# CAMBRIDGE HISTORICAL COMMISSION

## APPLICATION FOR CERTIFICATE

Two new windows on North-facing side of the building.

**From:** Michael Bentley <bentley@linnaean.com>  
**Sent:** Tuesday, April 26, 2016 10:44 AM  
**To:** Burks, Sarah  
**Subject:** Proposed windows at 1734 mass Ave - trim photos and dimensions  
**Attachments:** window.lower.rail.sill.IMG\_2130.JPG; window.sides.top.IMG\_2131.JPG

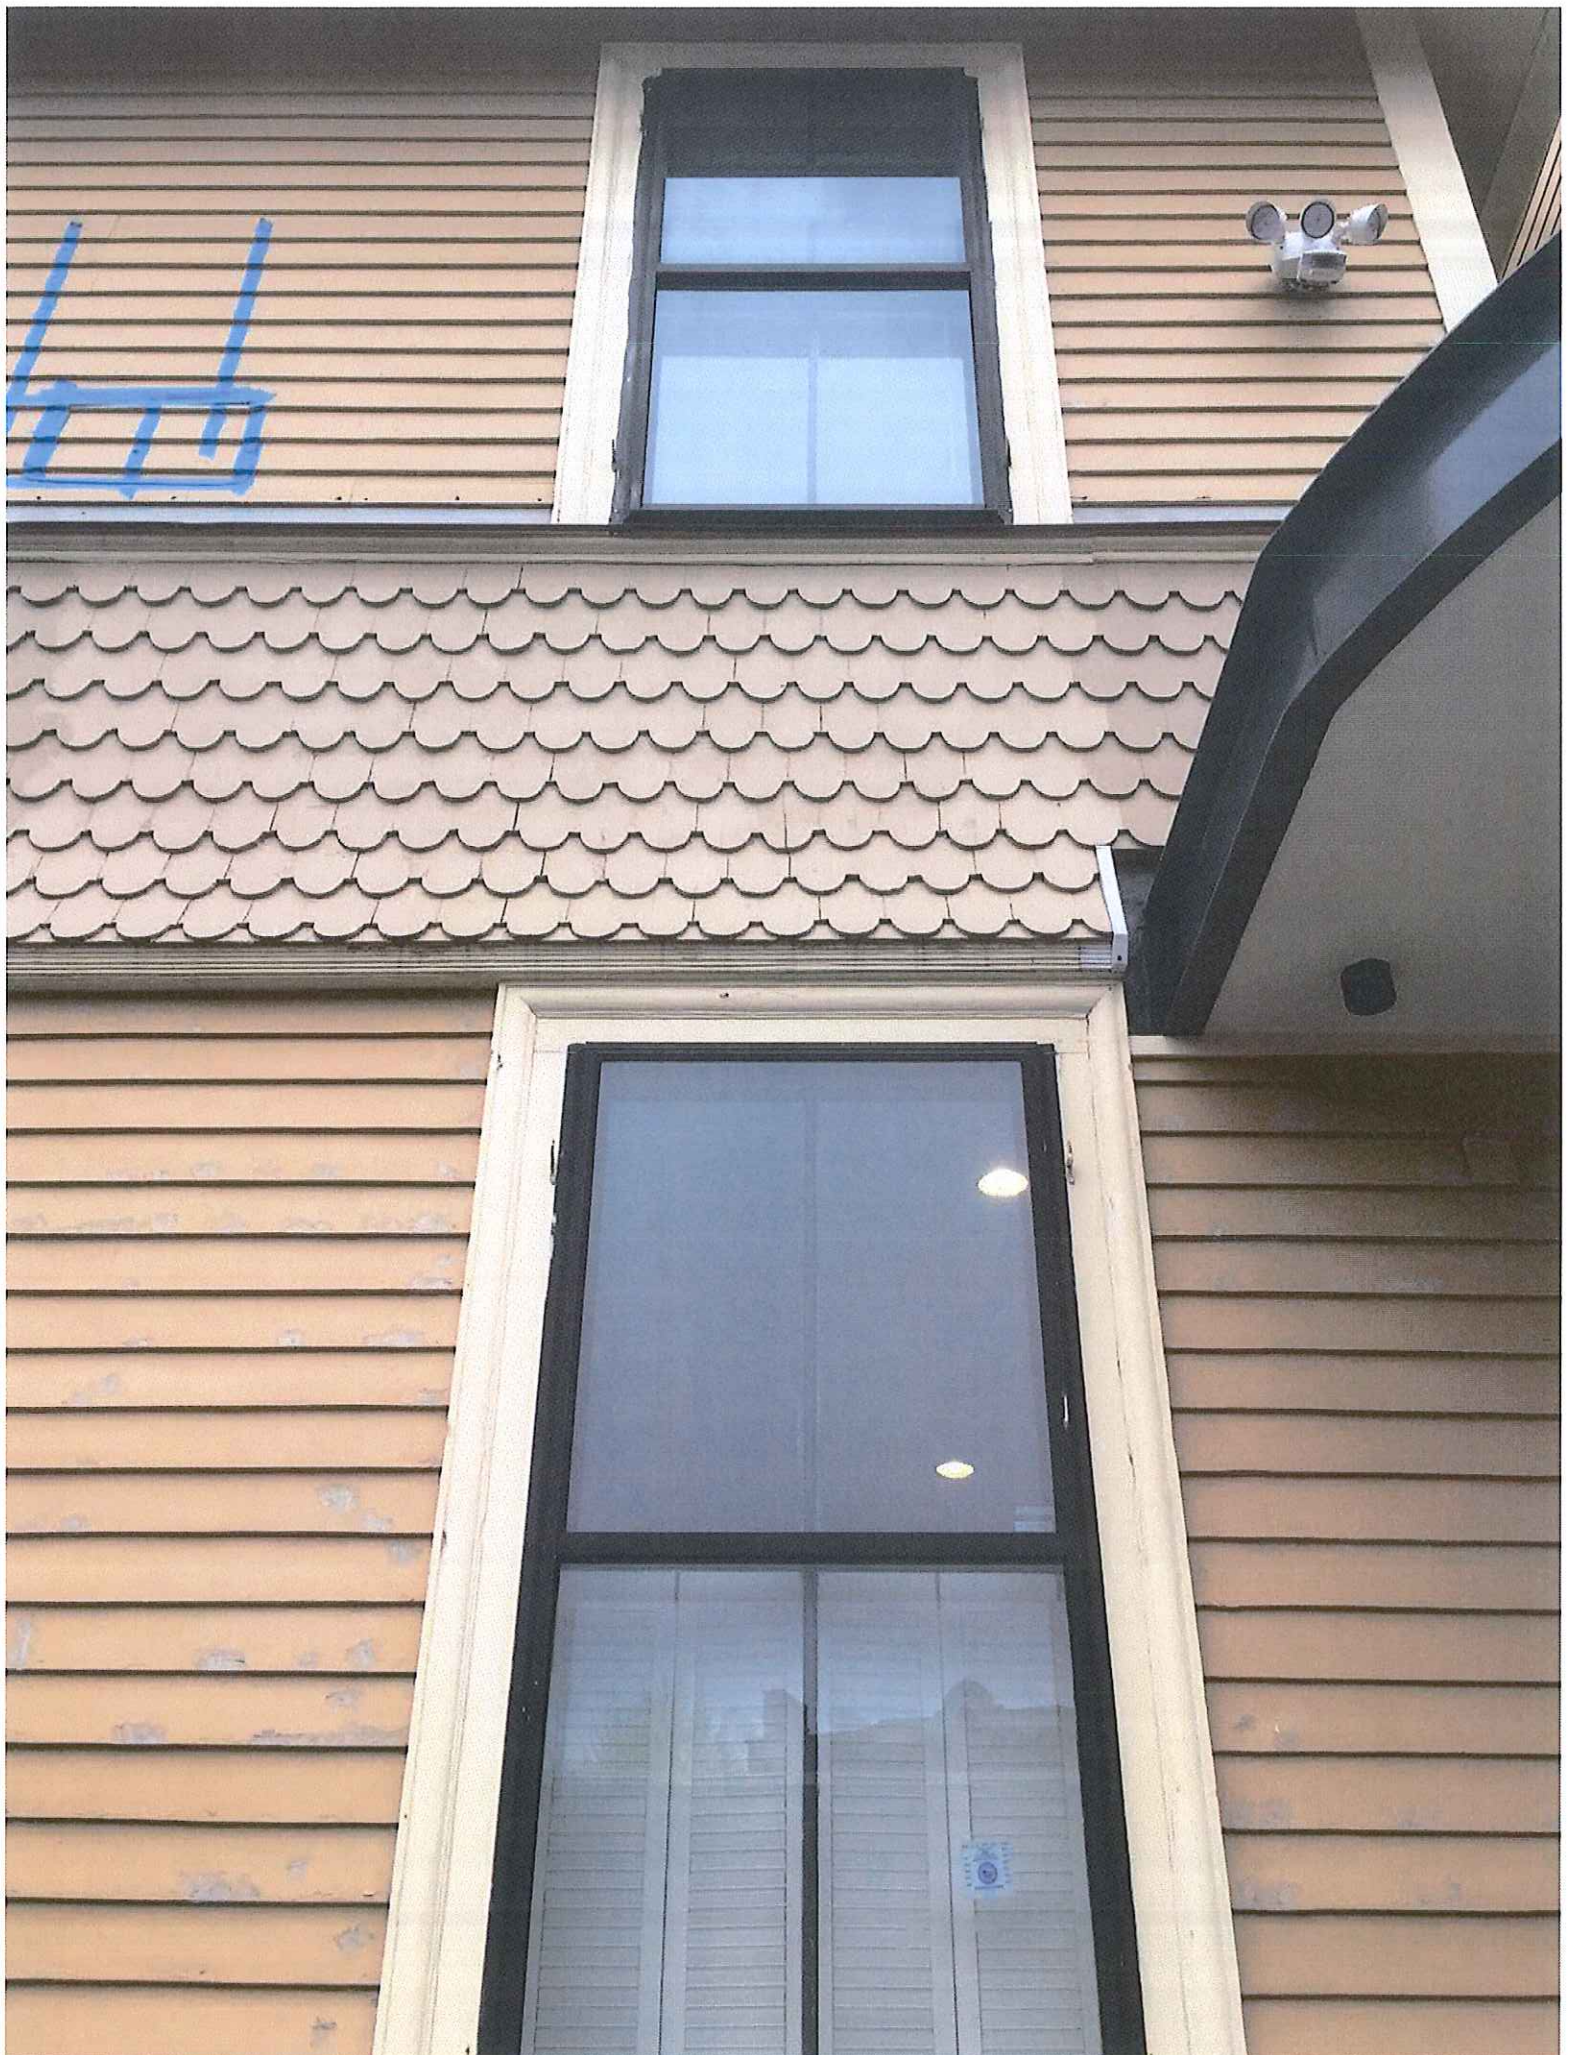
width of stile?

width of rail?

I was looking for dimensions of the stiles and rails that make up the sash (the size of the vertical and horizontal members). If it's going to match the historic window, if you can just document what those dimensions are, that'll be fine. 2 inches, 3 inches?

The attached photos show the trim / moulding that we propose to match.

- \* Stile measurements on each window is 1 and three quarter inches
- \* Rail measurements are shy of 3 inches
- \* Flat trim around each window is 6 inches and the band Moulding is 3 inches

We have proposed a single unbroken pane of fixed glass in the new windows. I tried to be clear about that in my oral presentation to you and Charles - apologies for not being clear enough.

My rationale for single pane was: matching exterior wood trim and proportion of windows, but leaving the glass unbroken seemed to me less likely to draw attention to the windows, and to let them blend into the rhythm of existing design. My concern about breaking up glass into panes was that the windows are in drive, and will be seen up close by visitors in drive, and that often attempts to almost "forge" original construction seem to me to not quite work. From the inside of the building (not part of your concern, I realize), the single pane will probably seem less faux.
